## Schwartzwalder M-1977-300 - Denver Water's Additional Comments

Re: Schwartzwalder Mine – File No. M-1977-300, Colorado Legacy Land, LLC –  
Amendment Application (Amendment 6)

Subject: Schwartzwalder Mine Amendment 6 – Evaluation of Response to Secondary Adequacy Review on Application and Response to Comment Matrix

**Mine Pool Uranium Concentrations**

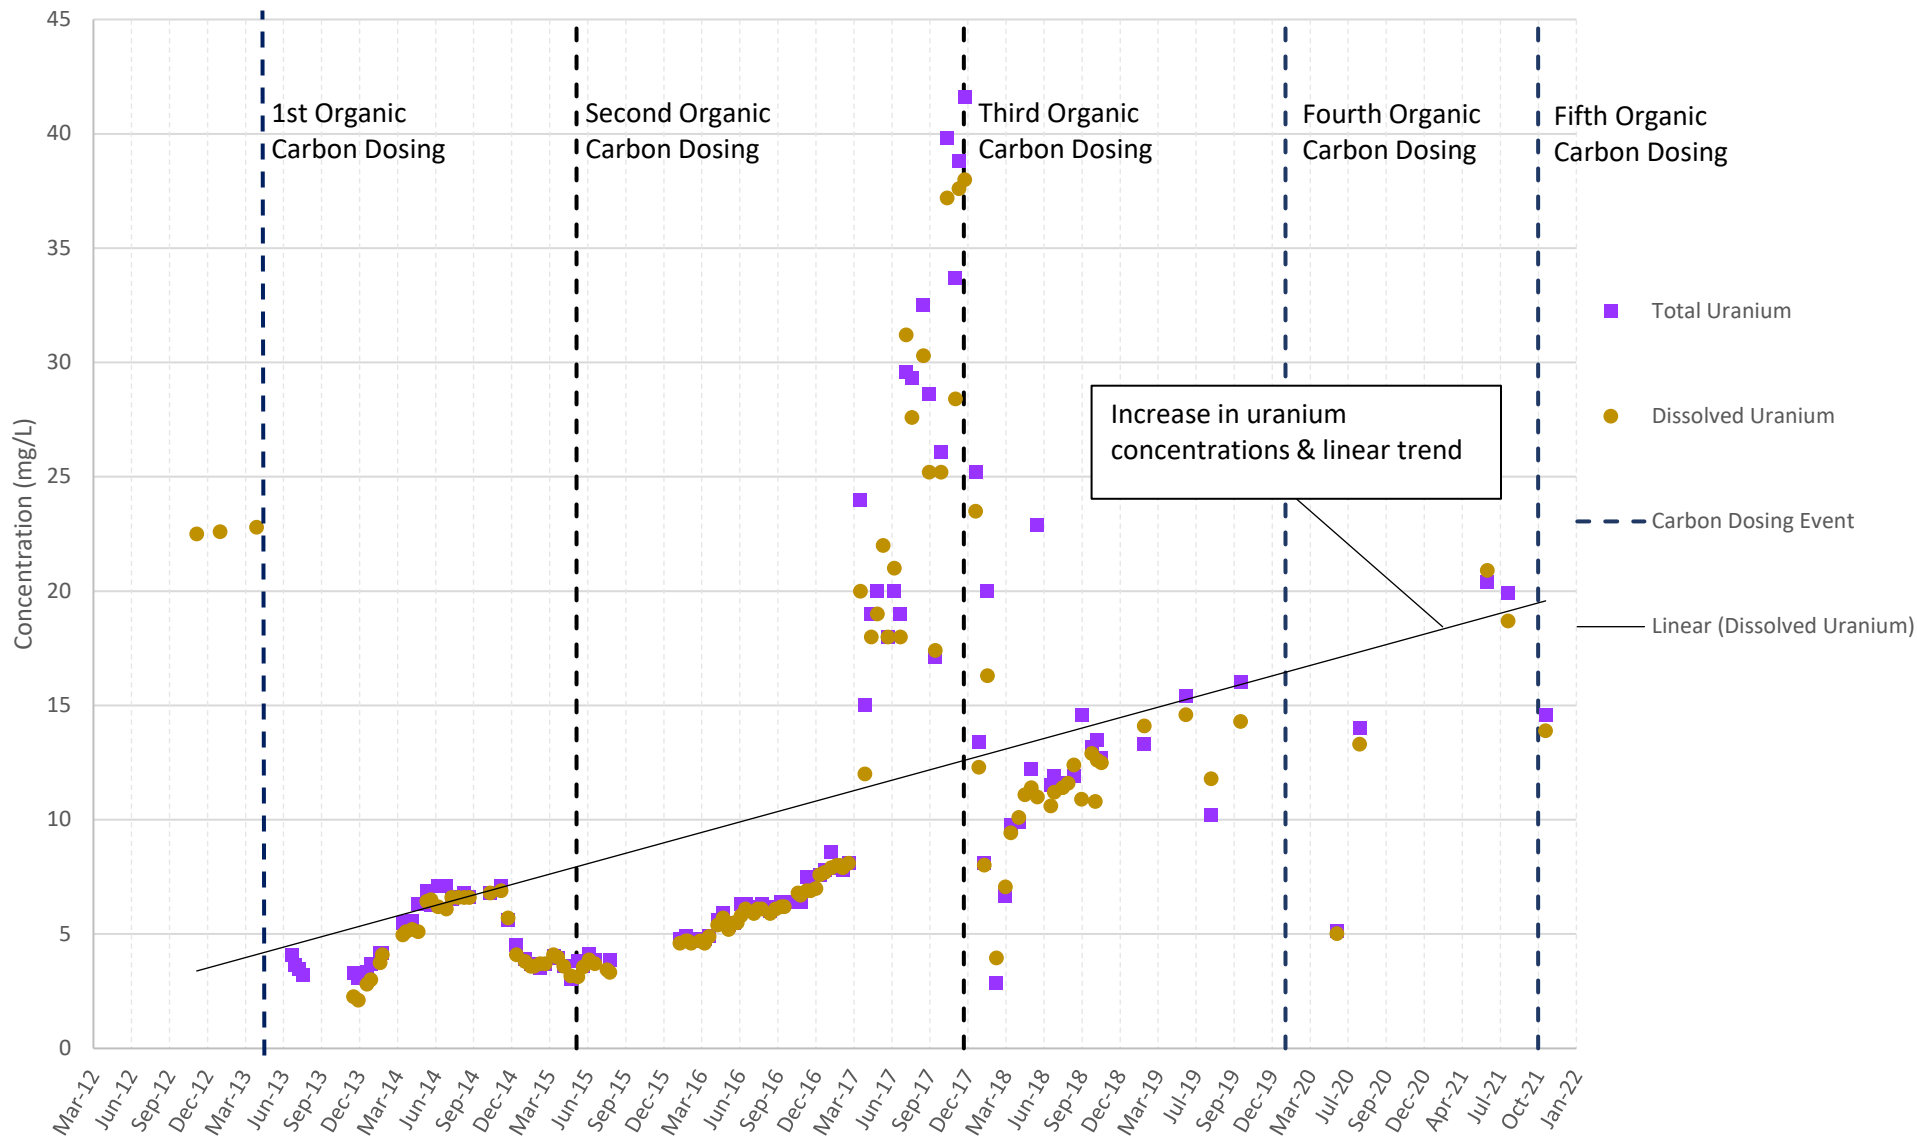
- CLL’s argument on stable discharged uranium concentrations does not sufficiently address the overall increasing uranium concentrations in the mine pool over the past few years. See the graph and Mann-Kendall trends provided as Attachments A and B, respectively (see CLL response to Denver Water Comments #2a, 20, 21, 23).

- CLL has not sufficiently addressed that the most recent in situ treatment did not decrease uranium concentrations (see CLL’s response to Denver Water Comments #2a, 17, 18). CLL’s response to Denver Water Comment #17 states that “CLL is not relying on in-situ treatment for the operations of the RO treatment systems” and that the mine pool is chemically stable. However, mine pool uranium concentration trends are increasing (Attachment A), despite increased frequencies of in situ treatments.
